文件编号 Document No.	ESP-00-2-007-03	文件名称 Document Name	产品/工艺变更通知 Product/Process Change Notice (PCN)
文件版本 Document Version	1.1	保存期限 Retention Period	3 年 3 years

增加 ASE 作为 ESP8266EX 芯片的封测厂 Introducing ASE as a new ATM plant for ESP8266EX									
PCN 编号 PCN No.	PCN-03-20200120	提出日期 Issue Date of PCN	2020/2/5						
产品名称 Product Name	ESP8266EX	变更日期 Proposed Date of Change	2020/2/5						
封装类型/尺寸 Package Type/Size	QFN 5X5	首次出货日期 Proposed Date of First Shipment	2020/3/10						
客户批准/Customer Consent: ☒ 需要批准/Approval Required ☐ 通知, 无需批准/Notification, Approval Not Required									
变更等级/Classification of Change: ☒ 主要变更/Major ☐ 轻微变更/Minor									
<u>变更原因/Reason for Change:</u> 为了增加 ESP8266EX 芯片供应链的多样性并提升产能。 In order to diversify the supply chain and increase the production capacity of ESP8266EX chips.									
<u>变更描述/Description of Change:</u> 目前 ESP8266EX 在 Unisem 以及 JCET 进行封装和测试, 为了进一步增强供应链的多样性并提升产能, 因此引入 ASE 作为新的封测厂。 Espressif now has Unisem and JCET to produce ESP8266EX. In order to further diversify the supply chain and improve production capacity, ASE will be introduced as a new Assembly and Test Manufacturing (ATM) plant.									
<u>影响产品/Impacted Products:</u> ESP8266EX									
<u>

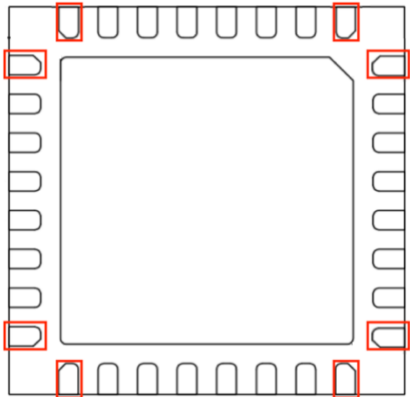
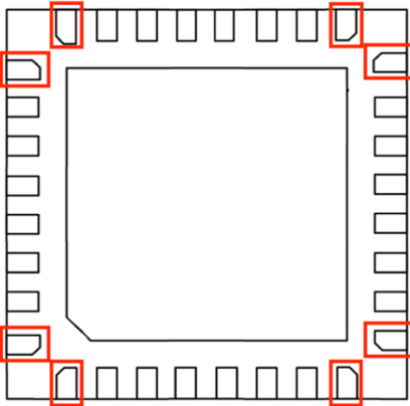
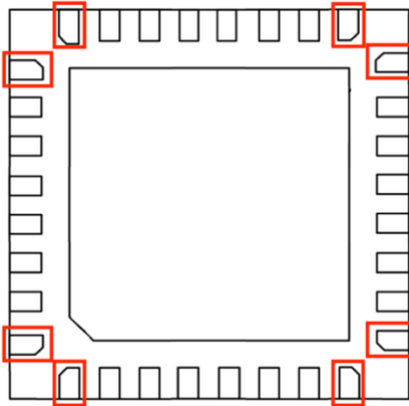
Unisem Chen Du Co., Ltd	江苏省长电科技股份有限公司	日月光半导体制造股份有限公司
引脚顶为弧形。 The top of the pads is circular. 四个边角对应的 8 个引脚顶的形状与其他引脚不同。(见下图) The pads located at the corners of the chip (see pictures below) have different shape from the other pads.  Bottom View 侧视图不同，两侧没有框架连接点。(见下图) The side views are different. There are no joint points of the lead frame at two sides. (see below).  Side View	引脚顶为直线。 The top of the pads is rectangular. 四个边角对应的 8 个引脚顶的形状与其他引脚不同。(见下图) The pads located at the corners of the chip (see pictures below) have different shape from the other pads.  Bottom View 侧视图不同，两侧有框架连接点。(见下图) The side views are different. There are two joint points of the lead frame at two sides. (see below)  Side View	引脚顶为直线。 The top of the pads is rectangular. 四个边角对应的 8 个引脚顶的形状与其他引脚不同。(见下图) The pads located at the corners of the chip (see pictures below) have different shape from the other pads.  Bottom View 侧视图不同，两侧有框架连接点。(见下图) The side views are different. There are two joint points of the lead frame at two sides. (see below)  Side View

尺寸 (Size)

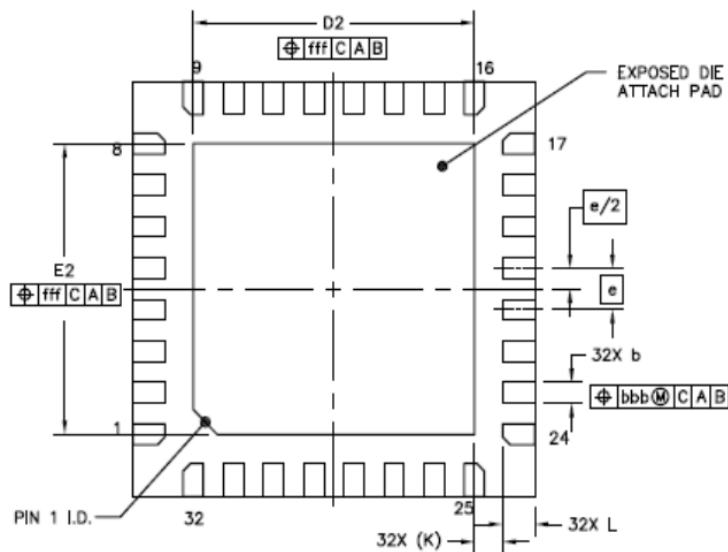
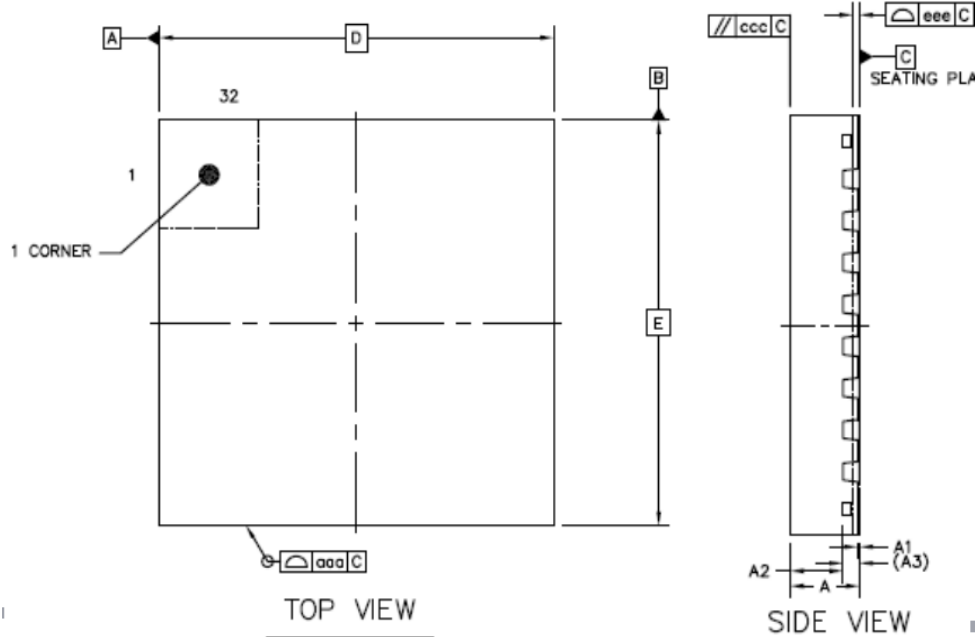
Unit: mm	Unisem Unisem Cheng Du Co., Ltd			JCET 江苏长电科技股份有限公司			ASE ASE Technology Holding Co., Ltd		
尺寸	MIN	NORM	MAX	MIN	NORM	MAX	MIN	NORM	MAX
A	0.8	0.85	0.9	0.8	0.85	0.9	0.8	0.85	0.9
A1	0	-	0.05	0	-	0.05	0	-	0.05
A3	0.203REF.			0.203REF.			0.203REF.

D	4.95	5	5.05	4.9	5	5.1	4.9	5	5.1
E	4.95	5	5.05	4.9	5	5.1	4.9	5	5.1
D2	3.65	3.7	3.75	3.4	3.5	3.6	3.4	3.5	3.6
E2	3.65	3.7	3.75	3.4	3.5	3.6	3.4	3.5	3.6
b	0.2	0.25	0.3	0.2	0.25	0.3	0.2	0.25	0.3
e	0.5 BSC			0.5 BSC			0.5 BSC		
L	0.35	0.4	0.45	0.3	0.4	0.5	0.3	0.4	0.5
切脚	C0.300×45°			C0.300×45°			C0.300×45°

- 在 ASE 生产的 ESP8266EX 产品将在芯片外观上, 包括引脚尺寸和形状与 JCET 完全一致, 但是与 Unisem 略有区别。
The ESP8266EX chips manufactured at ASE are the same in appearance as JCET, while slightly different from Unisem.
- 若客户产线 SMT 贴片模具可以兼容 JCET 生产的 ESP8266EX 芯片, 将能够同时兼容 ASE 生产的芯片。
If the customer's production line SMT mold is compatible with ESP8266EX chip produced by JCET, it will be compatible with ASE chip.
